SIMTA Intermodal Terminal Project – Moorebank Precinct East Stage 2

Peer Review

Project Number: 82017122-01/Report 001 Ver 1

Prepared for
Liverpool City Council

Figure 3-1 Land to which Part 2.4 of the Liverpool Development Control Plan Applies

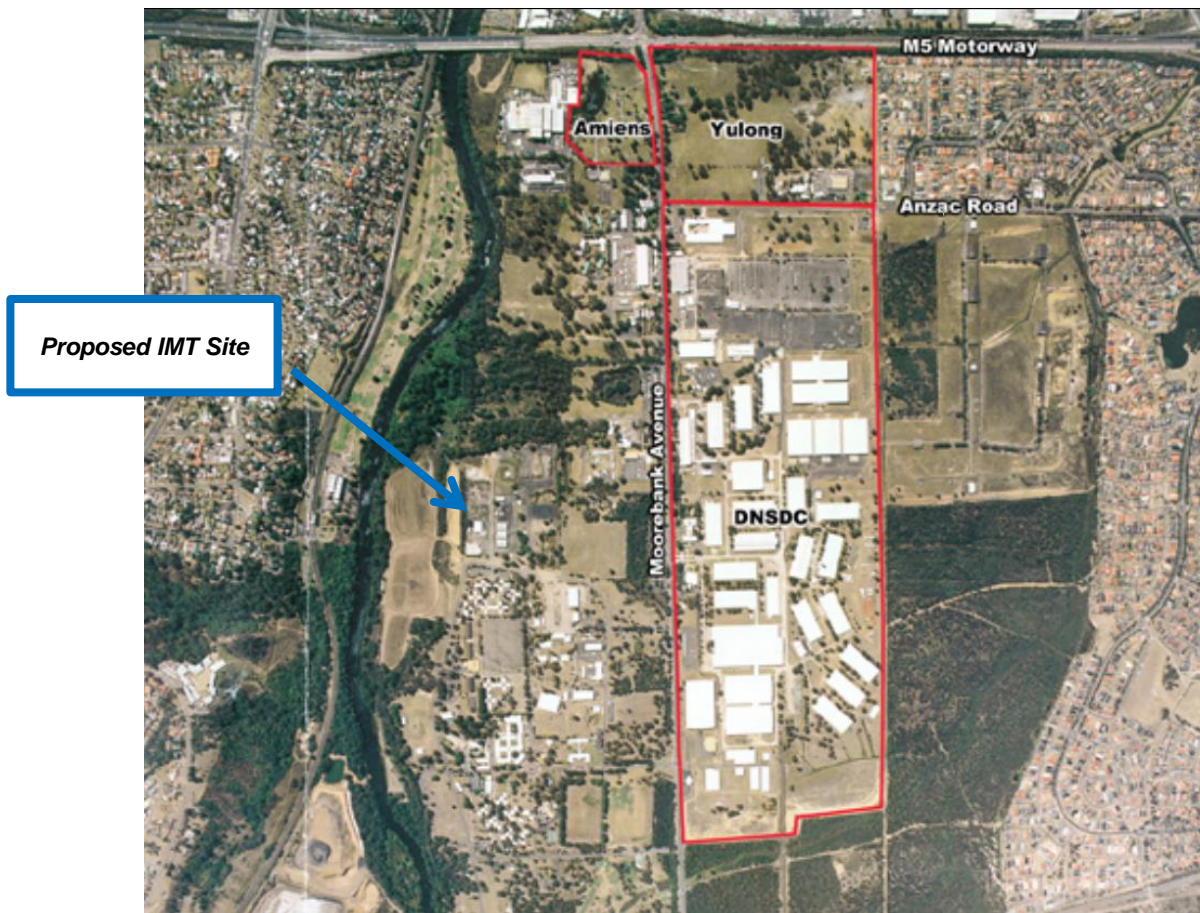
The MPE development provides some direct economic benefits to the LGA in the form of employment. However, the impacts on the surrounding amenity and transport networks, will create indirect impacts on the economy and social fabric of the LGA.

The development does not encourage or allow for the manufacture of advanced technology products and will impact on the amenity of the immediate surrounds, as well as land adjacent to the associated transport corridors. The loss of land due to the scale of the proposal creates a one dimensional development that limits opportunities for a wider range of employment generating activities, while impacting on the amenity of the area. Furthermore, the proposed scheme does not encourage a high standard of urban design, as discussed at **Section 3.11**. Consequently, the MPE scheme is counter to the requirements of the Liverpool DCP Part 2.4. A statement should be prepared identifying how the development satisfies the provisions of the DCP, with this Statement provided to Council for discussion to ensure that it meets the intent of the DCP.

- > While it is noted that DCPs are not required to be addressed by SSD, the applicant should consider redesign to allow compliance with Council's strategic planning, as illustrated through the controls within Part 2.4 of the DCP to allow the proposal to integrate with the surrounds and future vision for the area.
- > The Stage 2 application should be placed on hold pending the outcome of Modification 2.
- > DP&E should consider the consistency of the Project with the Matters for Consideration within Section 79C of the EP&A Act.
